**University of New South Wales Health Translation Hub – SSD 10822510 –
Responses to Randwick City Council Submission (Traffic and Transport)**

JMT Consulting has been commissioned by the University of New South Wales (UNSW) to prepare this document in response to the issues raised by Randwick City Council in response to the proposed UNSW Health Translation Hub (HTH) State Significant Development (SSD) application (SSD-10822510).

Figure 1 Guide to the choice of path treatment for cyclists

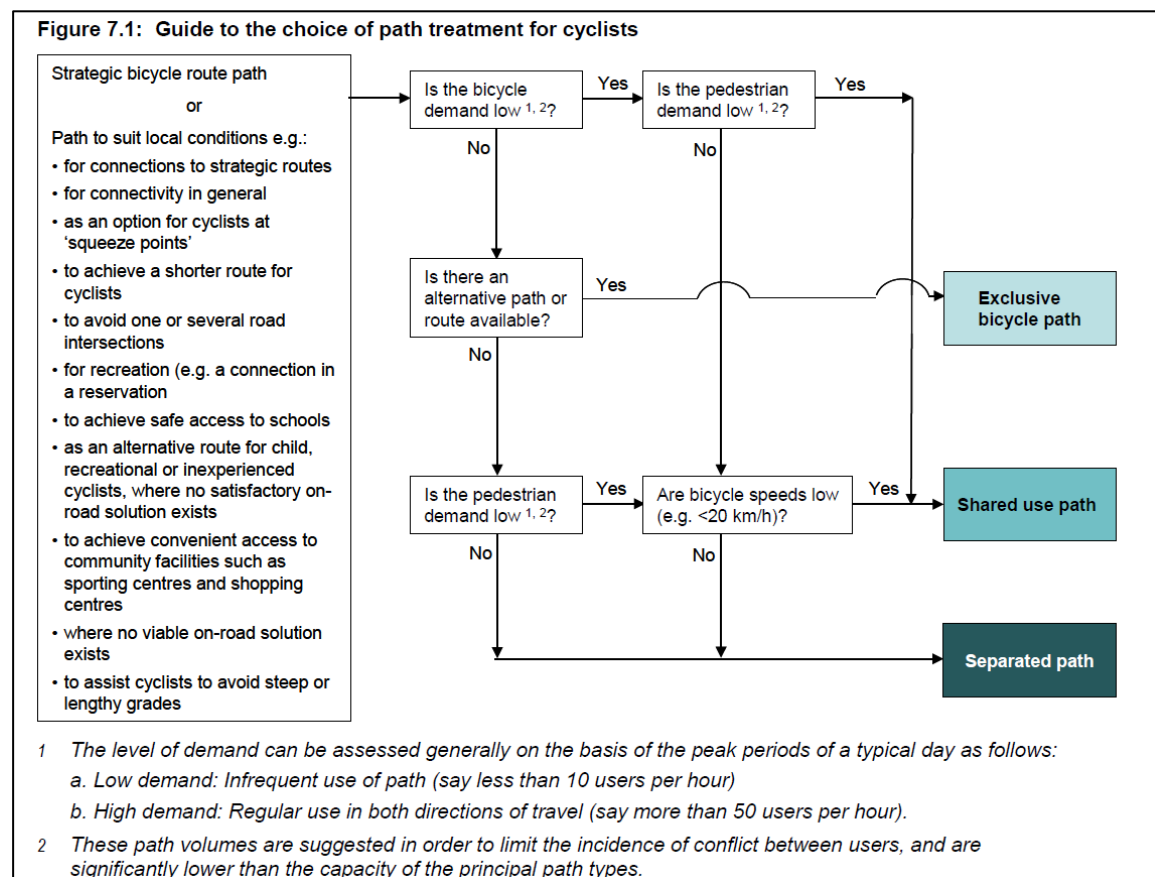
Randwick City Council have recommended that the proposal be amended to facilitate the introduction of a 3m (minimum) wide shared pathway on the southern side of High Street.

- High Street (east of Botany Street) is designated as a 40km/h 'High Pedestrian Activity Area' indicating high levels of pedestrian movements. This would include vulnerable users given the location adjacent to a major health facility, such as those with mobility impairments and pregnant women. Council in their response note that High Street will be a 'high volume link' for cyclists. In the context of significant levels of pedestrian movements (including vulnerable users) as well as high cycling numbers a shared path is not considered to provide a safe outcome. This is reinforced in Figure 7.1 of the Austroads Guide to Road Design document as reproduced in Figure 1 below.

- The Austroads Guidelines recommend a shared pathway be introduced only in circumstances where:
 - Pedestrian demands are low (less than 10 people per hour)

- Bicycle demands are low (less than 10 cyclists per hour)
 - Bicycle speeds are less than 20km/h

In the case of High Street, a designated high pedestrian activity area on a steep incline allowing for cycling speeds in excess of 20km/h, which according to Council will be a 'high volume link' for cyclists, a shared pathway is not considered to provide an appropriate cycle path treatment.
